Appendix D

RFLMA Contact Records

Figure 1. Road Maintenance Locations

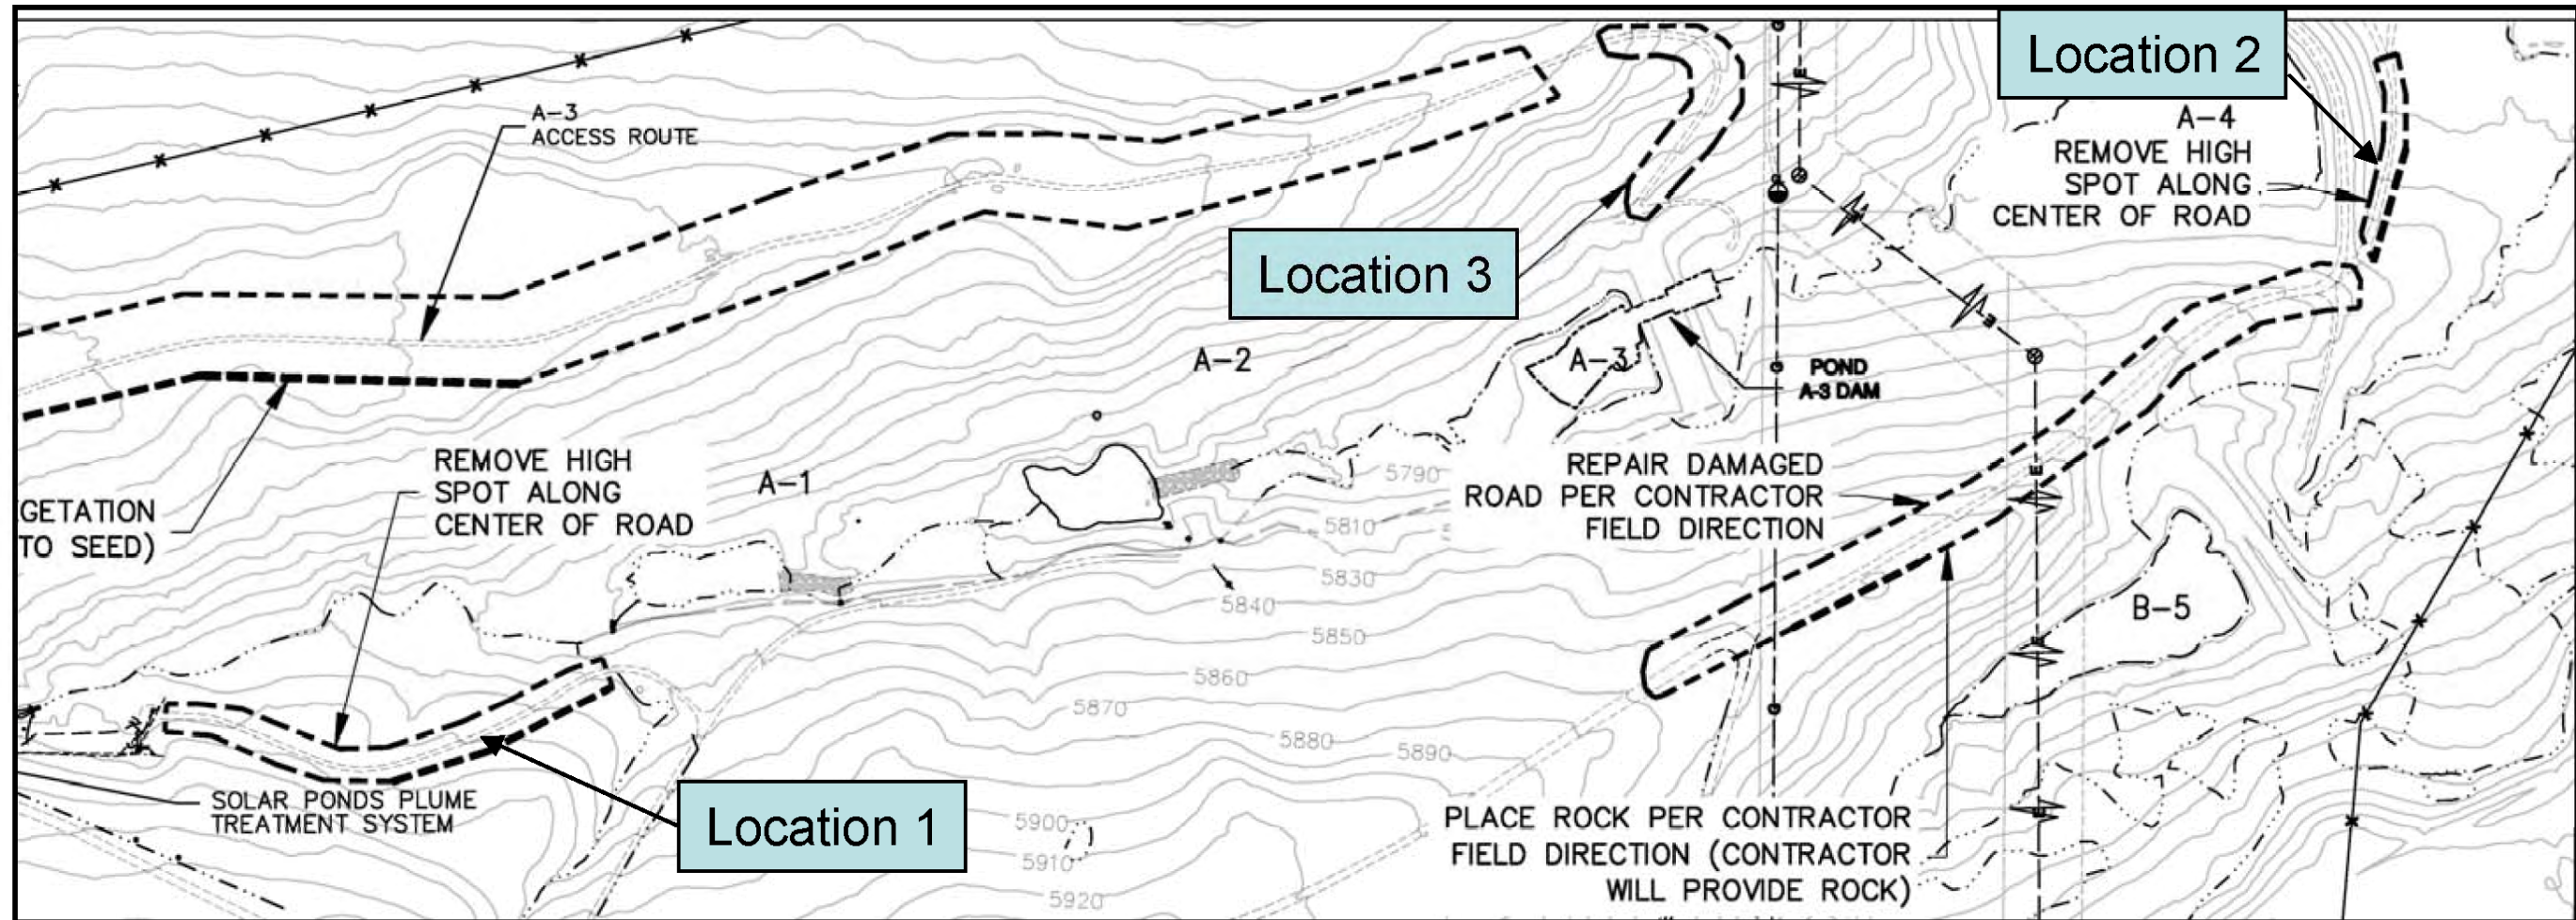
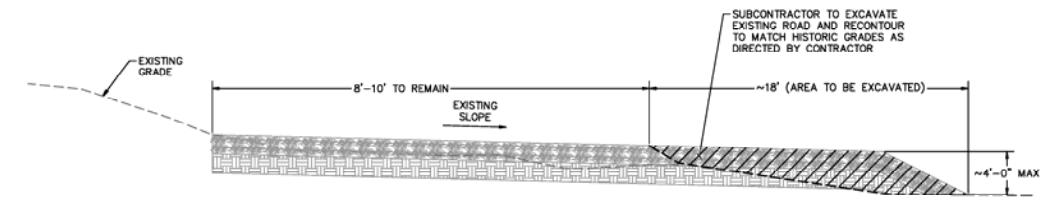
For clarity in this Soil Disturbance Review Plan, the areas under discussion are identified on Figure 1 as Locations 1 and 2 (gravel road sections where centerline humps will be removed) and Location 3 (a gravel road that will be regraded and revegetated for two-track vehicle use). The locations are as follows:

- **Location 1:** Gravel road access to the Solar Ponds Plume Treatment System Interceptor Trench System collection sump and related equipment and the SPOUT sampling location.
- **Location 2:** Gravel road access from the east face of Pond A-4 Dam to the WALPOC sampling location.
- **Location 3:** Gravel road access from the south-facing hillside to the former Pond A-3 and Surface Water Configuration Adaptive Management Plan sampling location GS12.

Figure 2. Road to Former Pond A-3

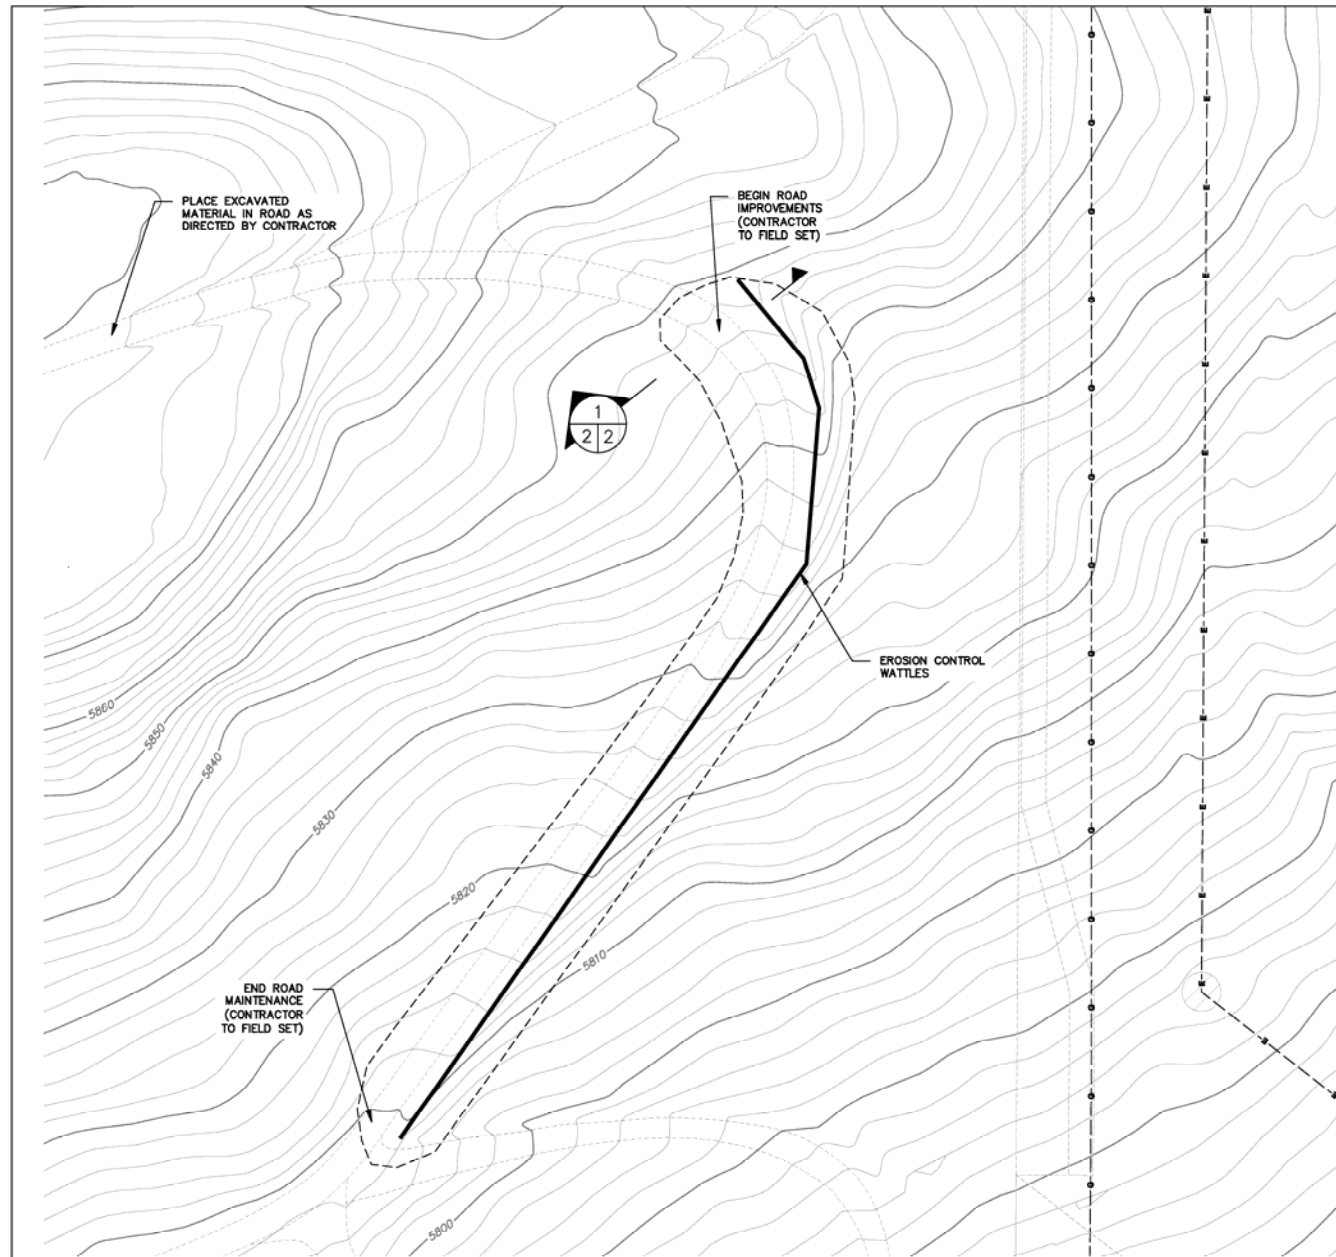
The dams for Pond A-3 and the Present Landfill (PLF) were breached as described in Contact Record 2011-07, “Soil Disturbance Review Plan—Pond A-3 and Present Landfill (PLF) Pond Dam Breach Project.” A truck-access gravel road will be maintained for the PLF area for inspection, monitoring, and maintenance of the PLF cover and the Present Landfill Seep Treatment System, but a two-track access road is all that is needed in the former A-3 Pond area for access to North Walnut Creek monitoring locations. That existing gravel road will be converted to a two-track road and will be revegetated and designated for two-track vehicle use. A portion of this road (on the hillside slope leading south to the former A-3 Pond) that was built up to accommodate trucks will be regraded to promote revegetation, to accommodate precipitation runoff, and to minimize the potential for erosion. The regrading will involve excavation deeper than 3 feet below the existing grade, and the surface will not be returned to the preexisting grade.

Figure 3. GS10 Flume Replacement Features

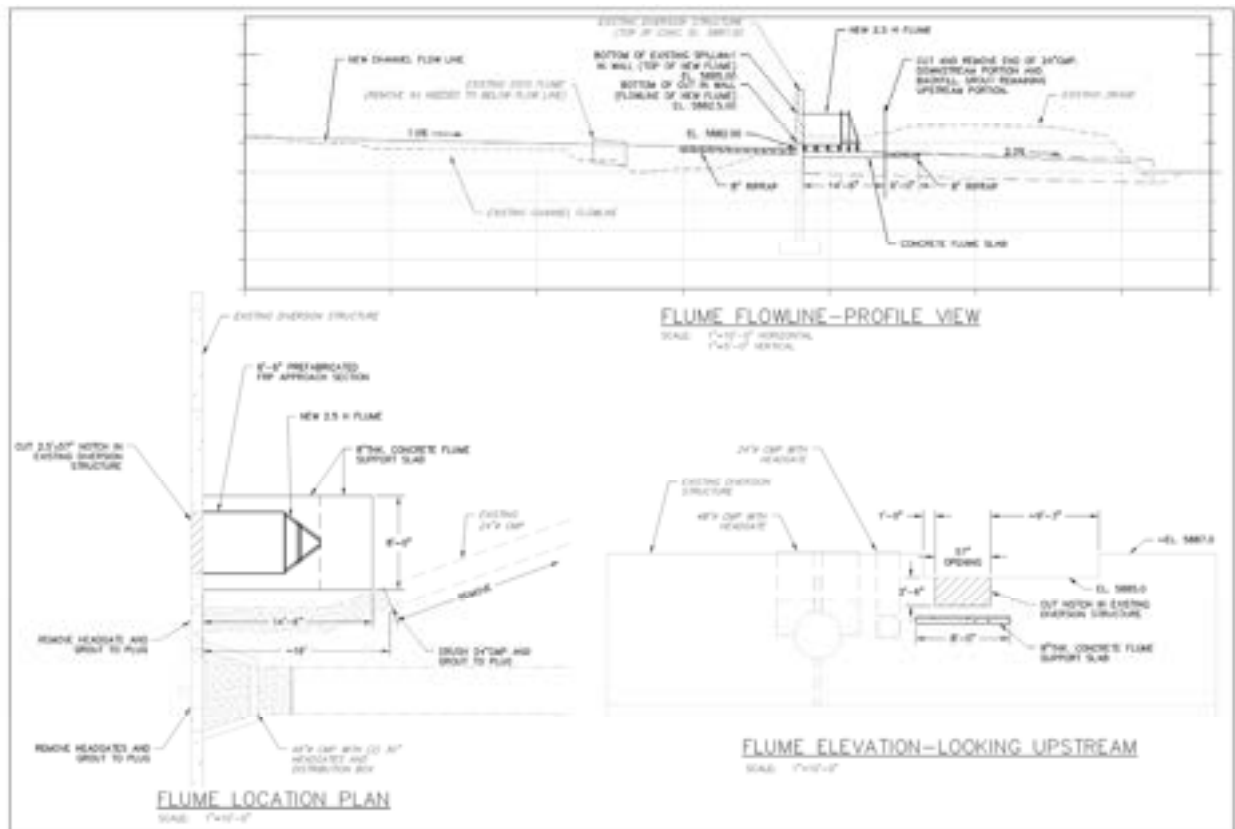
Flume Replacement Scope and Sequence: Figures 2 and 3 show the project area and the main features related to the work sequence.

The work will be sequenced as follows to provide continual monitoring at GS10 to the extent practicable during the anticipated 2- to 3-week active construction period.

8. The headgates will be removed and the CMP openings plugged with grout or other suitable material to seal the openings and provide long-term stability to eliminate this potential flow path.
9. The current GS10 flume will be removed to the extent needed for grading the channel, and the monitoring equipment for the current flume location will be removed. The concrete base for the flume and concrete equipment pad will be removed to a depth suitable for backfilling the remnants in place for the final grading.
10. Filling, grading, and contouring of the area upstream of the cutoff wall will be completed.
11. The cofferdam will be removed.
12. Post construction erosion controls and revegetation will be completed.

Figure 1. General Location of Cracking Observed on OLF Cover

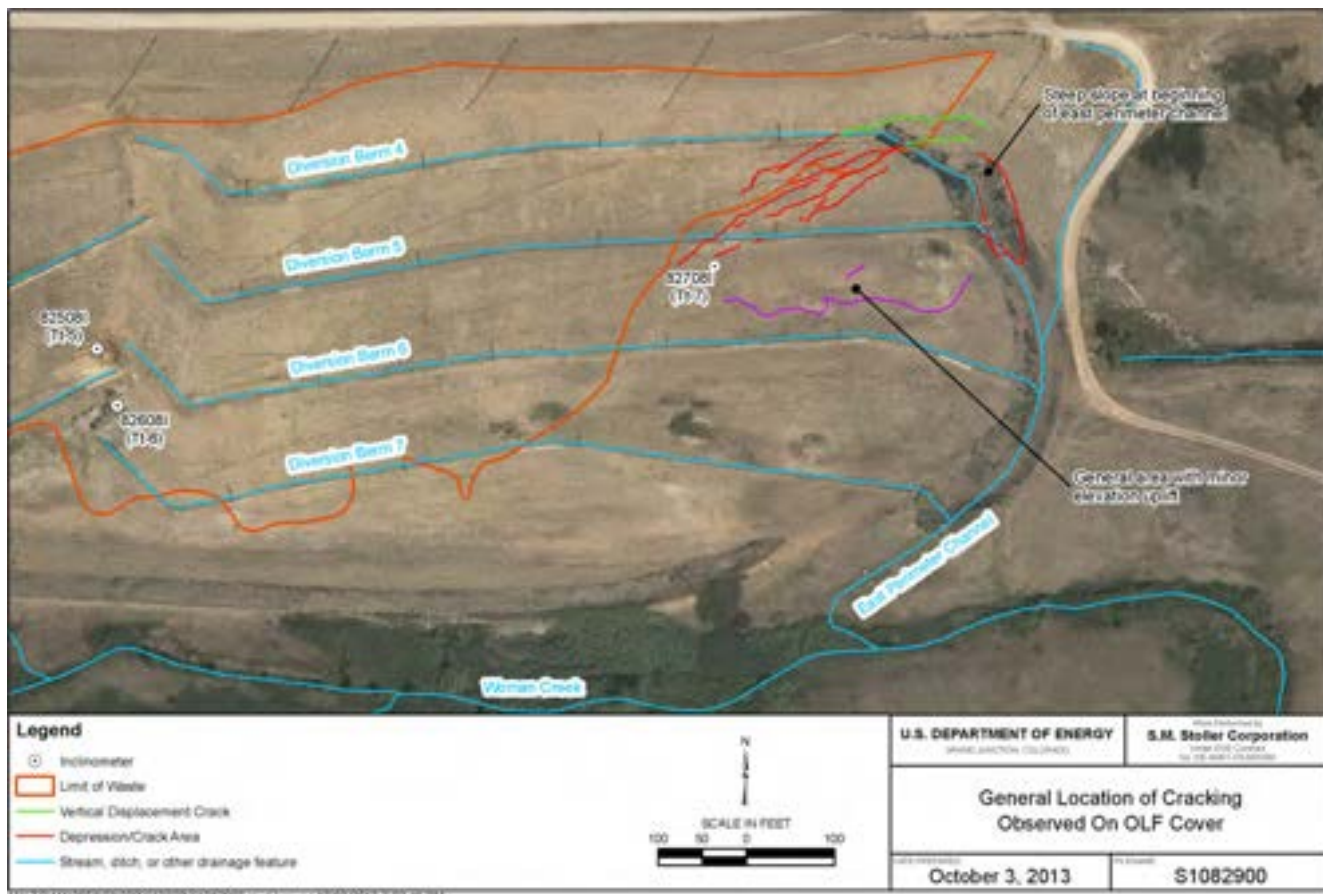
Cracks with vertical displacement of up to approximately 2 feet and cracks up to approximately 0.5 feet wide were observed during the inspection. The cracking and settling extended through portions of Diversion Berms 4 and 5, and a minor depression was formed in the Diversion Berm 4 channel between the cracks. Figure 1 shows the general location of the observed cracks based on handheld GPS measurements.

DOE informed CDPHE and EPA of the cracking on the northeast side of the OLF on September 17, 2013. DOE, CDPHE, and EPA personnel toured the area on September 18 to start the consultative process to develop a proposed course of action.

Resolution: CDPHE concurs with DOE’s conduct of the initial response work described above. The work meets the objective and rationale of IC 6.

CDPHE, after consultation with EPA, approves the plan and schedule for evaluation.

Figure 1. Slope Stability Model Results

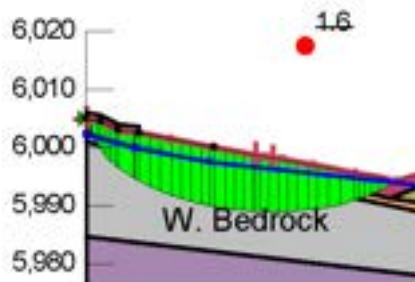
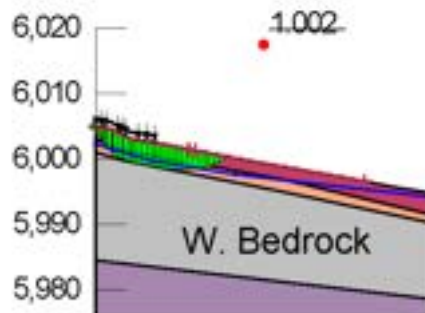
to 1.002 and the failure is predicted to occur in the organic layer at the surface of the weathered bedrock. These results indicate that the slope is marginally stable and on the verge of failure following the addition of two feet of fill. Because a localized, minor failure did actually occur when the water level increased, but without an additional surcharge, the model results may actually under-predict the potential risk of additional failures if surcharge is added.

Another alternative that would appear to have a lower risk for decreasing stability of the area is the construction of a temporary drain in the invert of Berm 4 to convey water from the low segment eastward to the outfall. This could be a trench and flexible drain pipe constructed such that the upper end of the drain is at the downstream end of the low segment and the drain outfall is at the eastern end of Berm 4 or in the EPC. This drain could be removed when longer term remedies have been designed and constructed (see below).
